SAN MIGUEL SUBDIVISION
(UNITS 1, 2, & 3)
P.U.D. / M.D.P. PLAN

Re: San Miguel Subdivision, Units 1,2, & 3

MDP # 427-H

SUBJECT: San Miguel Subdivision, PUD / MDP (Update) Level 1 T.I.A.

ENTRANCE DETAIL

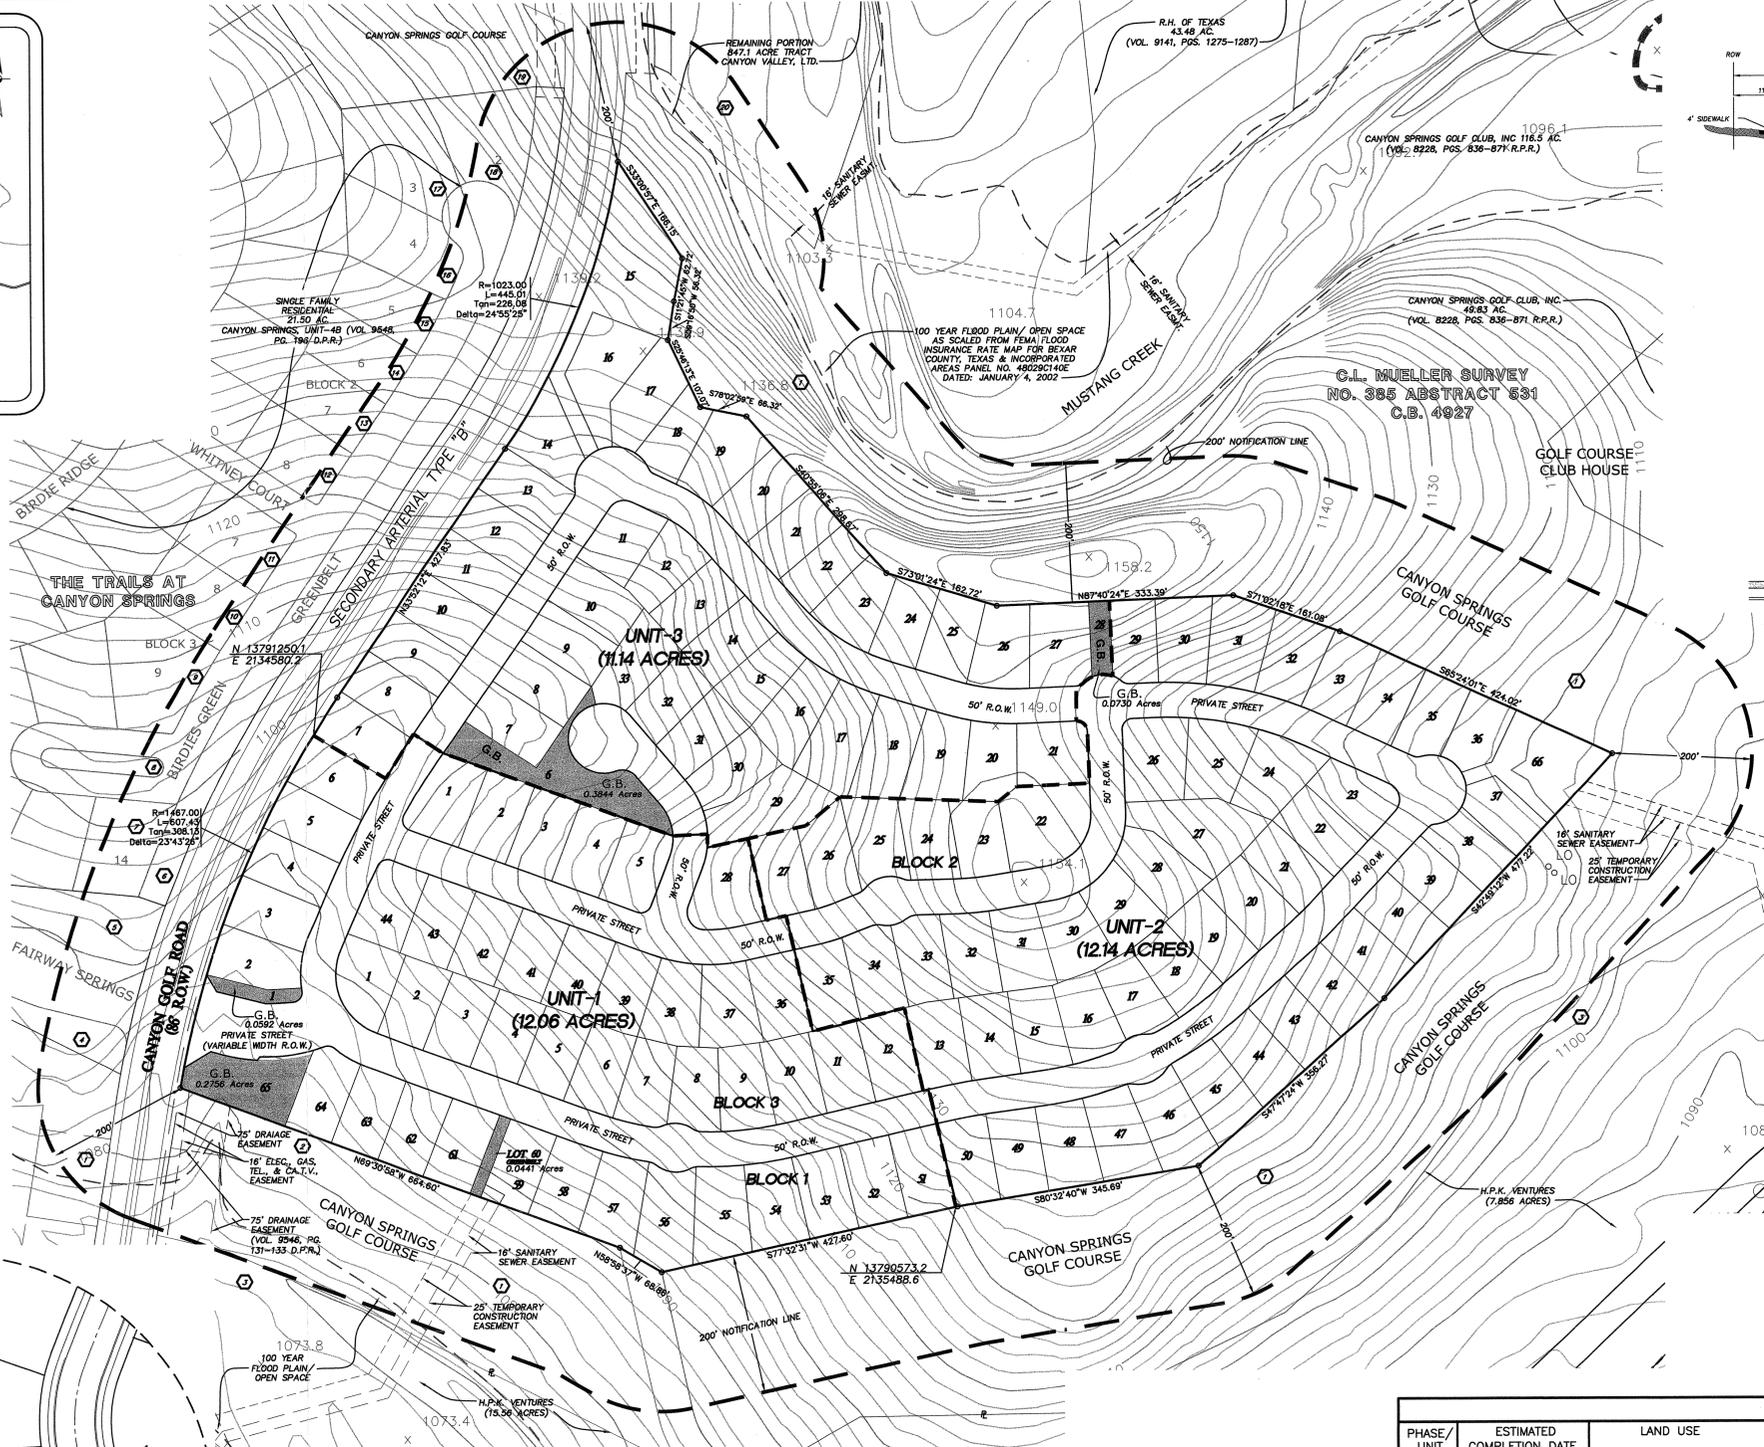
- The Development services Engineering Division has cited the following conditions as part of their conditional approval:
 1. A right-turn deceleration lane is recommended if conditions are adaptable at the entry.

Due to the amount of northbound right-turn vehicles into this single-point entry, a right-turn deceleration lane is recommended if existing conditions are adaptable.
